Summary of Public Review Comments and Responses:
Draft Inventory of U.S. Greenhouse Gas Emissions and Sinks: 1990-2022

July 2024
U.S. Environmental Protection Agency
Office of Atmospheric Programs
Washington, D.C.

Responses to Comments Received during the Public Review Period on
the *Inventory of U.S. Greenhouse Gas Emissions and Sinks: 1990-2022*

Figure 1: Trends in U.S. anthropogenic methane emissions between 1990 and 2022.

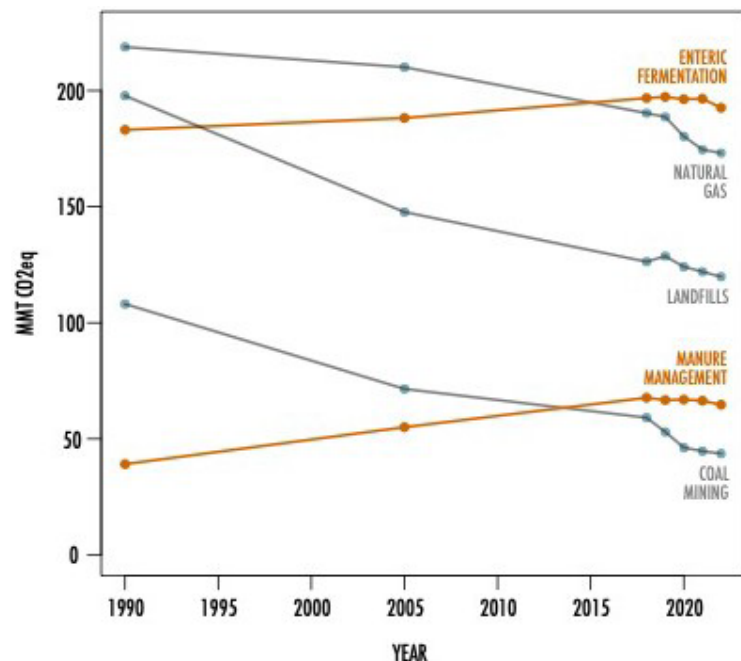
Methane emissions from animal agriculture, which account for 36 percent of total anthropogenic methane emissions,⁵ have increased since 1990. In particular, methane emissions from enteric

fermentation—a digestive process in cows and other ruminant animals that produces methane as a by-product—rose from 183.1 to 192.6 MMT CO₂eq (million metric ton carbon dioxide equivalents) between 1990 and 2022.6 Methane emissions from manure management grew from 39.1 to 64.7 MMT CO₂eq during the same period.

Figure 2: Supply chain emissions and carbon opportunity costs of various foods.

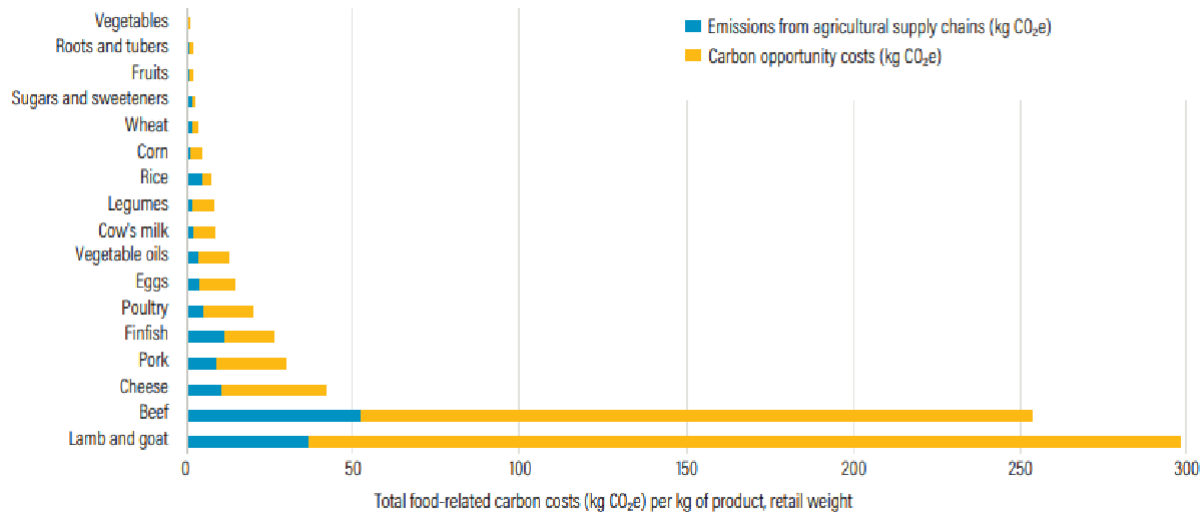
Neither the Inventory nor the agricultural economic sector estimates accounts for the carbon

opportunity cost of agricultural land use, a measure of how much carbon land could sequester if, rather than being used for agricultural production, it reverted to native vegetation. However, EPA has recognized that carbon opportunity costs can be included in estimates of emissions from land use changes. Figure 2 demonstrates the significant carbon opportunity costs associated with various foods.

Response: EPA notes this comment to further disaggregate the agricultural economic sector and will review the feasibility of updating the current economic sector analysis to provide additional disaggregation incorporating the LULUCF sector to the extent possible. While not disaggregated for specific manufacturing industries, EPA also notes that the manufacturing emissions from combustion are reported under the industrial sector in [Chapter 3-Energy](#) (see pp. 3-20). Process emissions during manufacture of chemicals are reported under [Chapter 4-Industrial Processes and Product Use](#) (see pp. 4-2 through 4-5).

Figure 3. Greenhouse gas emissions calculated according to 100-year and 20-year GWPs.

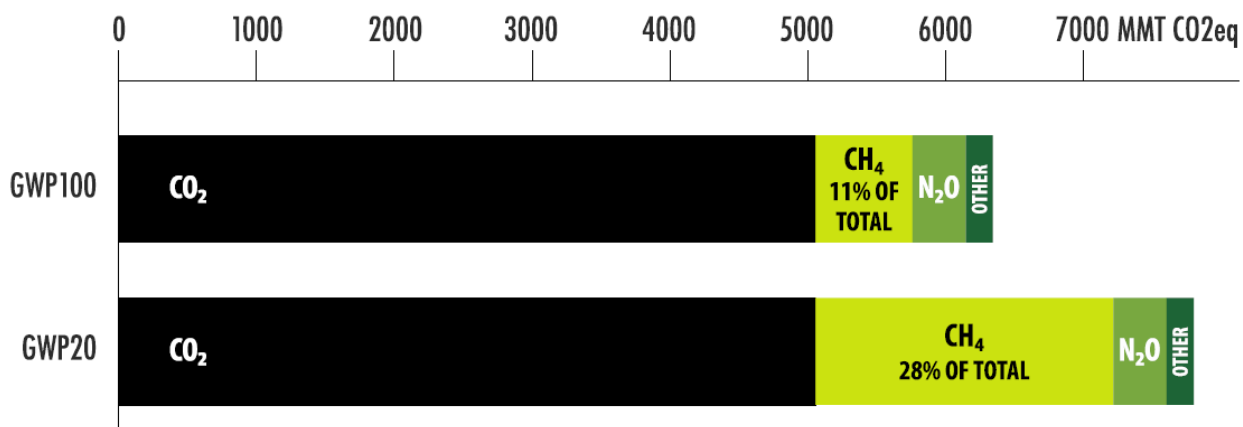
EPA should present greenhouse gas emissions in the Inventory using both 100-year and 20-year GWPs, as many scientists urge. To compare the global warming impacts of various greenhouse gases, scientists use GWPs, which represent the amount of heat absorbed by a single unit of a greenhouse gas over a specified timeframe. The Inventory relies solely on a 100-year GWP, representing the climate impact of a greenhouse gas distributed across a century. This choice has a significant impact on the Inventory’s calculation of methane emissions, as the GWP of methane is 28 at 100-year timescales and 86 at 20-year timescales. In other words, using 100-year GWPs weights methane emissions nearly three times less than 20-year GWPs. And, since methane remains in the atmosphere for about 12 years on average, this choice also obscures methane’s tremendous near-term impact on the climate. While methane accounts for 11 percent of U.S. greenhouse gas emissions with a 100-year GWP, it rises to 28 percent when its impact is analyzed using a 20-year GWP.

Reporting greenhouse gas emissions using both 100-year and 20-year GWPs would provide more relevant data for policymakers, whose work often occurs on the scale of years or decades rather than centuries. It would also comply with the IPCC directive to tailor GWP choices to their appropriate policy contexts. And it would align with similar state-level reporting, such as in New York state’s greenhouse gas inventory and in its climate planning.

Response: EPA uses 100-year Global Warming Potentials (GWP) from IPCC’s Fifth Assessment Report to calculate CO₂ equivalent emissions as required for reporting annual inventories under the UNFCCC and the Paris Agreement. This is required to ensure that national GHG Inventories reported by all nations are comparable. See page ES-3 of the Executivity Summary to the Inventory report here: https://www.epa.gov/system/files/documents/2024-04/us-ghg-inventory-2024-chapter-executive-summary_04-16-2024.pdf.

The U.S. Inventory also includes unweighted estimates in kilotons (see Table 2-2 of the Trends chapter) and stakeholder/researchers can and have used these values to apply other metrics. Further, Annex 6 of the Inventory includes information on effects to inventory estimates in shifting to AR5 and AR6 100-year GWPs. The U.S. Inventory report website is available at <https://www.epa.gov/ghgemissions/inventory-us-greenhouse-gas-emissions-and-sinks>. More

Figure 3: Agricultural greenhouse gas emissions with 95 percent confidence intervals.

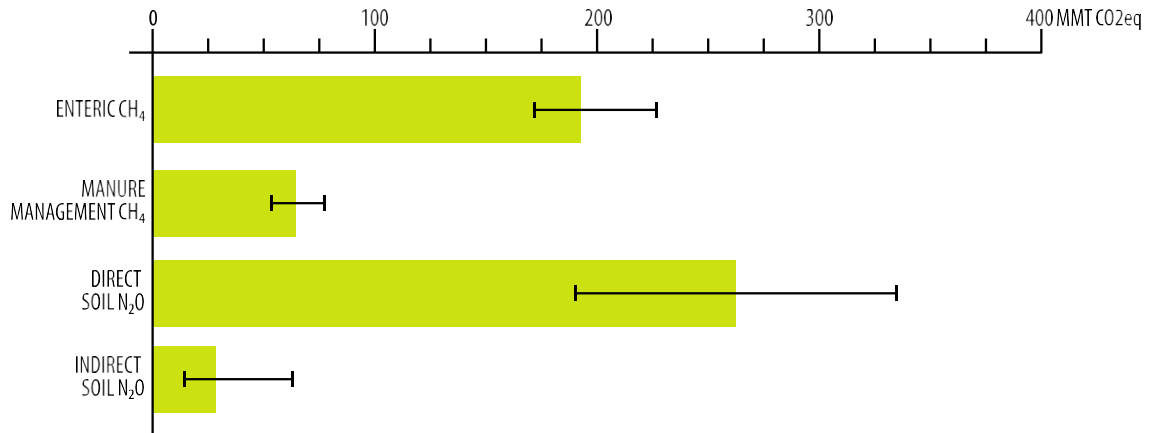
EPA should prioritize reducing the uncertainty ranges for agricultural emissions, which are among the largest in the Inventory. For example, for methane emissions from enteric fermentation, the 95 percent confidence interval—that is, the range of values within which there is a 95 percent likelihood that the true value falls—spans from 11 percent below to 18 percent above the estimate. For methane emissions from manure management, the confidence interval ranges from 18 percent below to 20 percent above the estimate. Even more concerning, the confidence interval for direct soil nitrous oxide emissions is only constrained to ± 28 percent of the estimate, and the interval for indirect soil nitrous oxide emissions ranges up to 123 percent above the estimate. By contrast, the confidence interval for carbon dioxide emissions from natural gas ranges from just 1 percent below to 5 percent above the estimate.

Given that agricultural emissions are already high and growing, it is critical that EPA improve the precision of these estimates. EPA has made only marginal improvements in the uncertainties over the past few years, so it must prioritize them going forward. Without accurate estimates for agricultural emissions, policymakers do not know the true extent to which agriculture is driving climate change and, thus, may not take the steps necessary to reduce its emissions.

Response: EPA agrees with commenter, consistent with IPCC good practice, that improving the inventory includes reducing uncertainty ranges as far as practicable, in particular for significant

sources that are the focus of these comments. This is a priority for EPA and collaborating agencies. The agriculture sector poses unique challenges in improving the activity data and emissions estimations models that underly many source categories within the agriculture sector in the absence of entity-scale reporting for agricultural sources of emissions. To this end, EPA is currently working on updates to the uncertainty analysis which will involved updating uncertainty parameters and the Monte Carlo simulation to accompany recent updates, as documented in the Planned Improvements sections for the following categories, for example, Enteric Fermentation (Page 5-11), Manure Management (Page 5-21), and Agricultural Soil Management (Page 5-47). This is a multi-year update and EPA will report on progress/publish results in future inventories.
